# Access Compliance Report

## Public Rights-of-Way

### (Curb Ramps)

Intersection ID: 50541	Main Street: CAYENNE_DR	Cross Street: LEMONGRASS_LN	Location: SE
ADA ID: 5B937A846730	Ramp Type: PerpDiag	Initial Pass/Fail: Fail	Overall Compliance: No
		Severity Score: 25

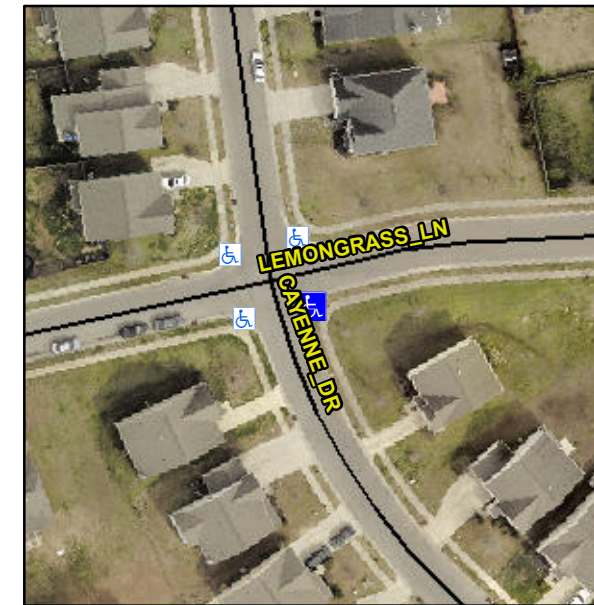
**Not Found, R304.2.2, R304.5.3**

Compliance	Description	Data	Compliance	Description	Data
N/A	Ramp Length (in)	48.5	No	Ramp Slope (%)	9.0
Yes	Ramp Width (in)	48.0	No	Ramp XSlope (%)	5.8
N/A	Flare Type LT	N/A	N/A	Flare Type RT	N/A
N/A	Flare Slope LT (%)	N/A	N/A	Flare Slope RT (%)	N/A
N/A	Flare Traversable LT?	N/A	N/A	Flare Traversable RT?	N/A
N/A	Landing Length (in)	N/A	N/A	DWS Provided?	N/A
N/A	Landing Width (in)	N/A	N/A	DWS Contrast?	N/A
N/A	Landing Slope (%)	N/A	N/A	DWS Length (in)	N/A
N/A	Landing X Slope (%)	N/A	N/A	DWS Full Width?	N/A
N/A	Landing Curb? (Y/N)	N/A	N/A	DWS Offset (in)	N/A
N/A	Shared Landing?	N/A			
N/A	Gutter Ponding?	N/A	N/A	Gutter Slope (%)	N/A
N/A	Gutter Lip Ht (in)	N/A	N/A	Gutter X Slope (%)	N/A
N/A	Painted X Walk1?	No	N/A	Painted X Walk2?	No
	X Walk 1 Direction	To N		X Walk 2 Direction	To W
N/A	X Walk 1 Width (in)	N/A	N/A	X Walk 2 Width (in)	N/A
	X Walk 1 Slope (%)	10.0		X Walk 2 Slope (%)	3.6
	X Walk 1 X Slope (%)	3.0		X Walk 2 X Slope (%)	6.8

**Remove & Replace Curb Ramp With Two New Directional Ramps or Equivalent.**
